Aja Tibbs
Senior Planner
City of Aurora
15151 East Alameda Parkway, 2nd Floor
Aurora, CO 80012

RE: Painted Prairie Master Plan Amendment with Adjustments

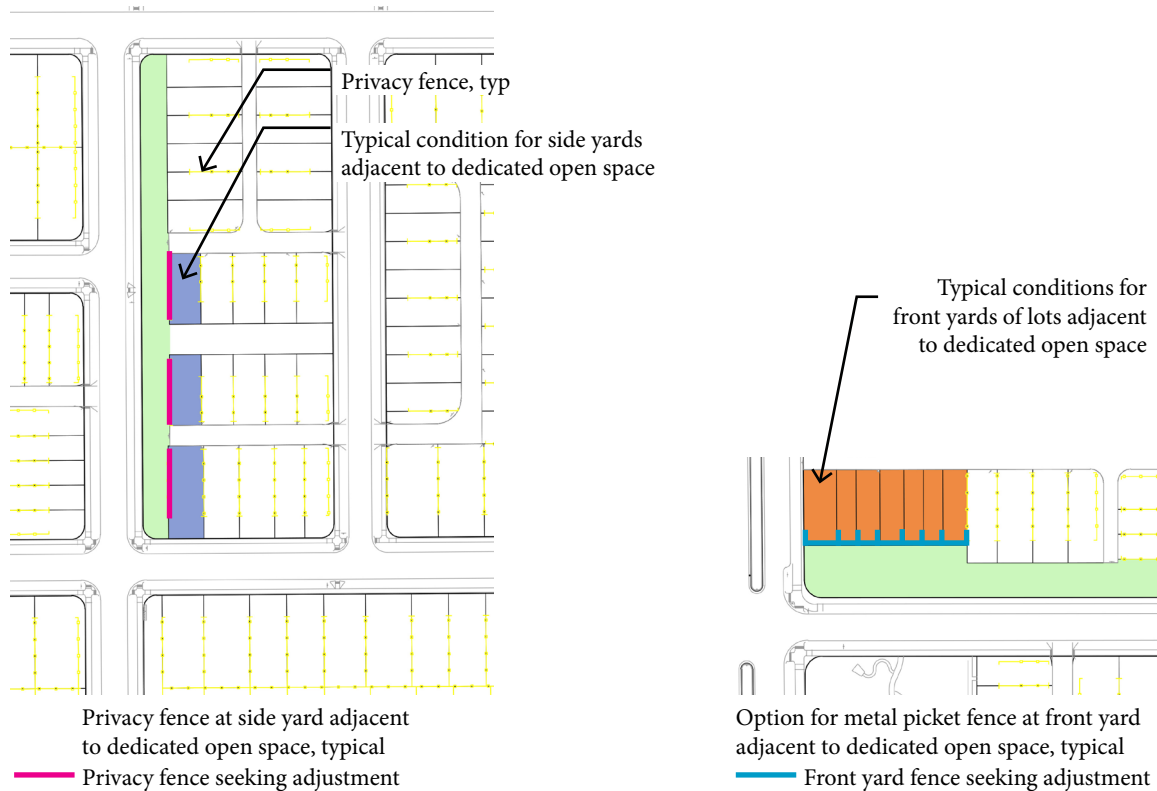
Painted Prairie seeks an adjustment from “fences adjacent to open space tracts, trails, and drainage ways shall meet the design standards shown in Figure 4.7-37” (see below), and is requesting the use of 5’ privacy fence for side yards adjacent to dedicated open space.

- For side yards on dedicated open space, the use of a 5’ privacy fence is being requested
- For front yards of lots on dedicated open space, the use of a 3’ metal picket fence is being requested.
- Specifically, open space demarcation fencing will still be used for lot lines directly adjacent to High Prairie Park, Prairie Retreat Park, and Pioneer Park.

The intention for the privacy fences for this adjustment is to provide a better quality neighborhood for both residents on lots seeking an adjustment, and also for all residents using the park space adjacent to said lots. The privacy fence at side yards adjacent to dedicated open space will block views into potentially distracting or cluttered side and rear yard areas where grills, yard trimmings, children's play equipment, etc are often kept. Similarly, the side yards for these lots are largely the usable yard space and can have patio space attached to them. Privacy fences in these locations will create a more comfortable living experience for lot owners who will not have their usable yard space and homes exposed to the adjacent and activated park space, nor the sidewalk and street. The fencing required by the UDO is not sufficient in providing privacy for home owners, or screening for park users. Below is an example of the UDO conforming fence which does not provide privacy for the resident of the lot, or a comfortable walking experience.

Mitigating factors for the use of privacy fences at side yard conditions adjacent to dedicated open space will be provided. The privacy fence will only be 5ft tall as opposed to a typical 6ft tall privacy fence. This is only 1ft taller than the UDO demarcation fence. Additionally, enhanced landscaping will be provided as described in the amended sheets at paseo type conditions, and for corner lots. Required enhanced planting is provided with in the amended sheets. The only option for privacy fence in these conditions will be the vertical option which has additional top rail detailing. Along the perimeter open space, the 40' setback from the public right-of-way helps mitigate the "fence-canyon" type effect.
